**BEFORE THE OHIO POWER SITING BOARD**

**NOTICE REGARDING CONDITION 17 COMPLIANCE**

**\*\* DETERMINATION OF NO HAZARD TO AIR NAVIGATION \*\***

**AERONAUTICAL STUDY NUMBER 2018-AGL-22989 and 22990-OE**

#### 6. BASIS FOR DECISION

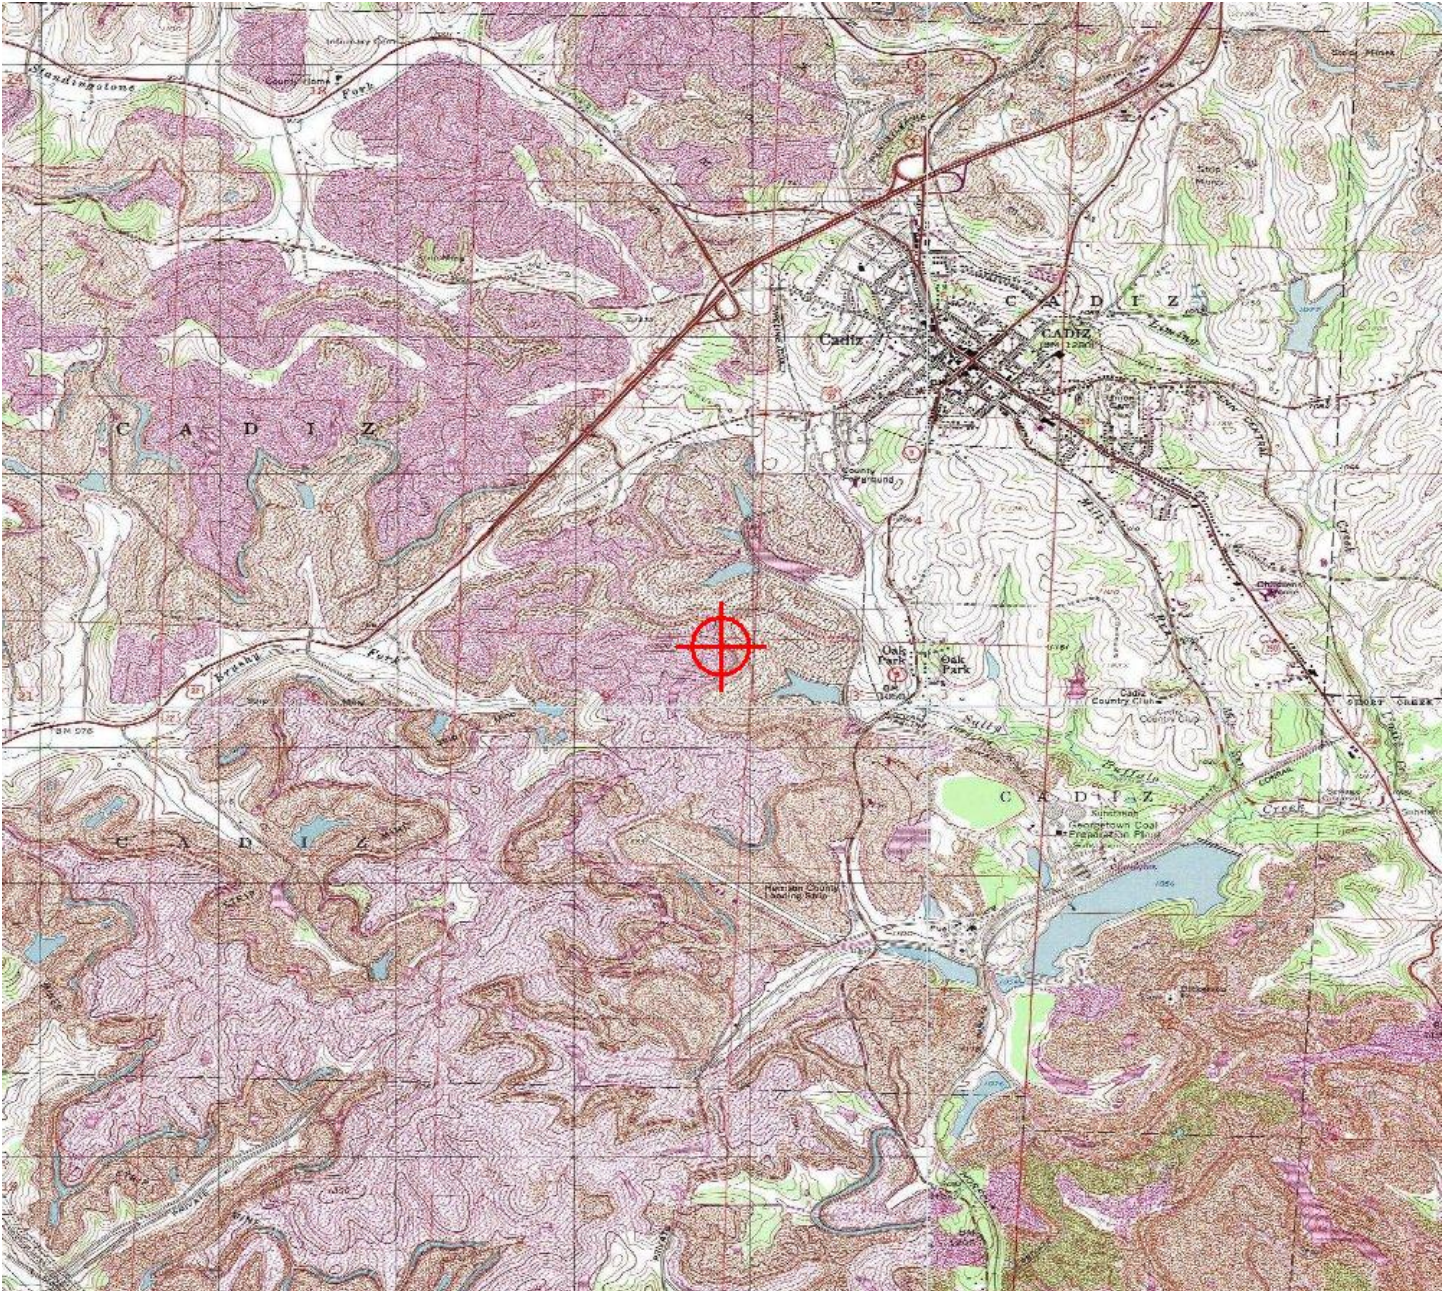
The proposed stacks would penetrate the VFR Traffic Pattern Airspace (TPA) by 65 feet; however, 8G6 has right traffic to RWY 13 therefore, all operations are conducted south of the airport and the proposed stacks would be located north of the airport. Due to the right traffic pattern for RWY 13, the proposed structures are considered to be outside of the VFR traffic pattern airspace. There are no IFR impacts and no other VFR issues were identified. The incorporation of lighting will provide additional pilot conspicuity for VFR and IFR operations in the vicinity of 8G6 airport.

#### 6. BASIS FOR DECISION

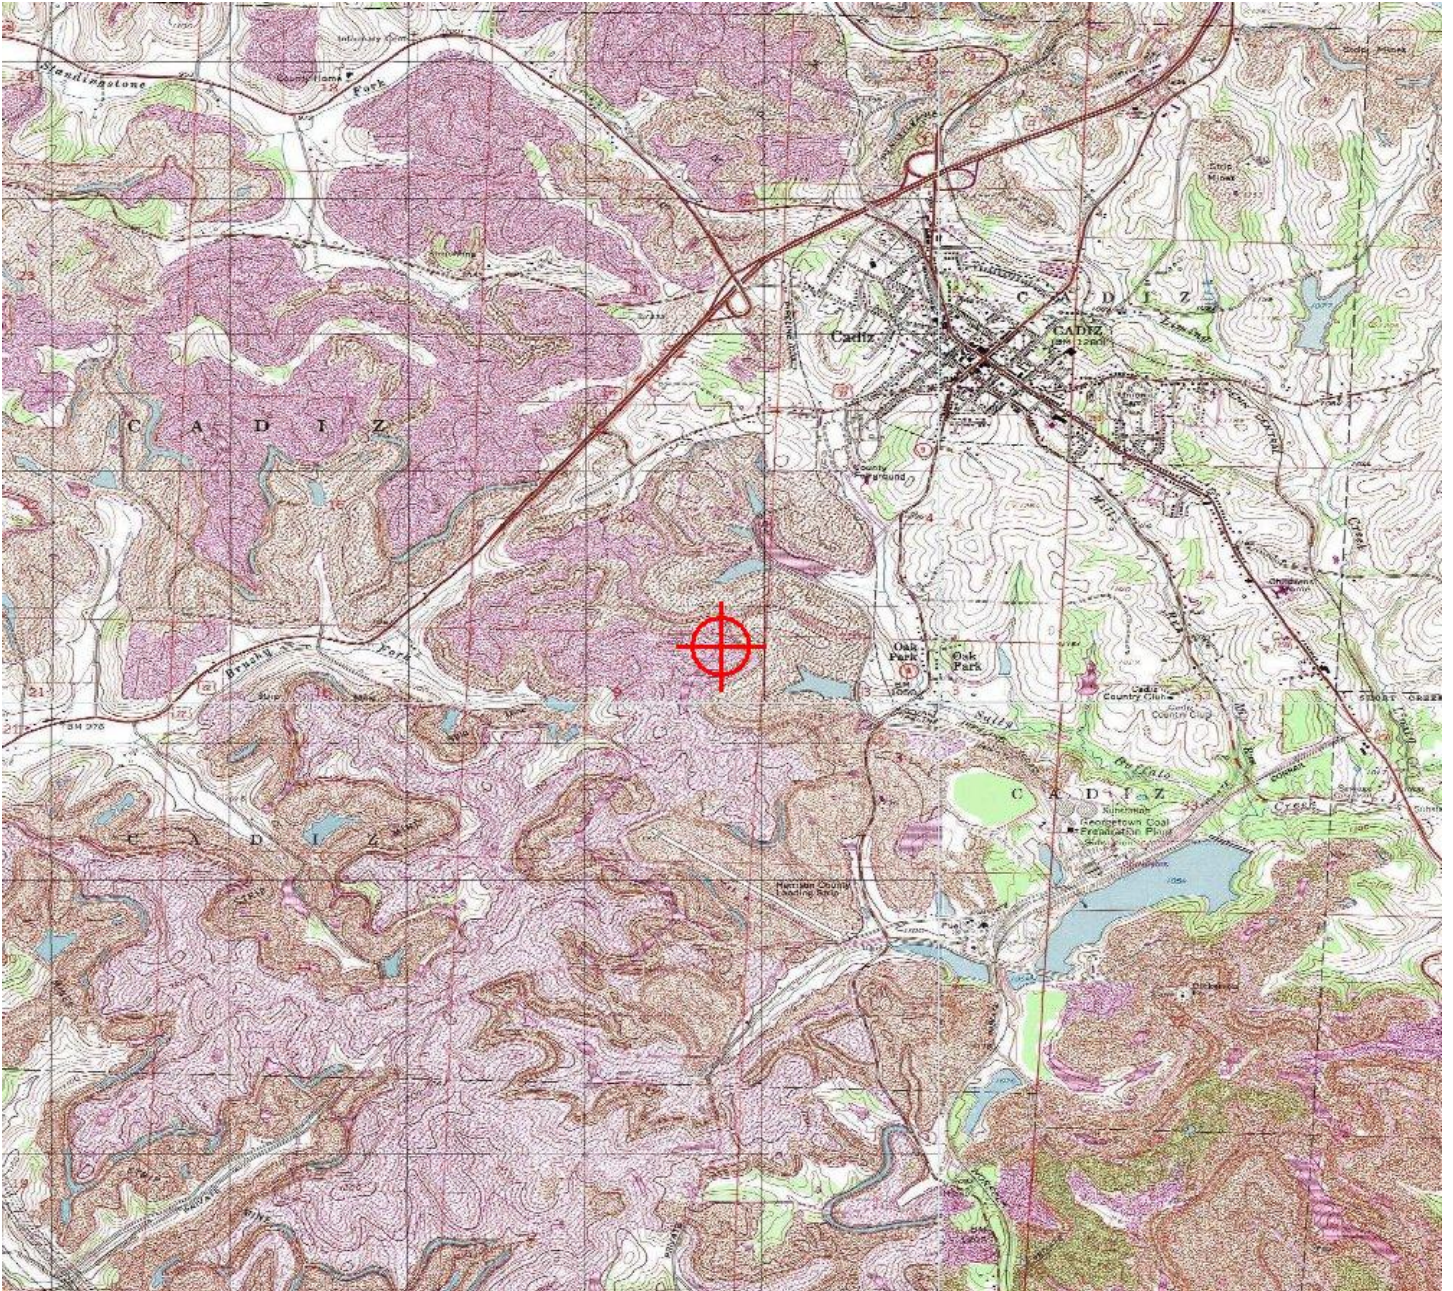
The proposed stacks would penetrate the VFR Traffic Pattern Airspace (TPA) by 65 feet; however, 8G6 has right traffic to RWY 13 therefore, all operations are conducted south of the airport and the proposed stacks would be located north of the airport. Due to the right traffic pattern for RWY 13, the proposed structures are considered to be outside of the VFR traffic pattern airspace. There are no IFR impacts and no other VFR issues were identified. The incorporation of lighting will provide additional pilot conspicuity for VFR and IFR operations in the vicinity of 8G6 airport.
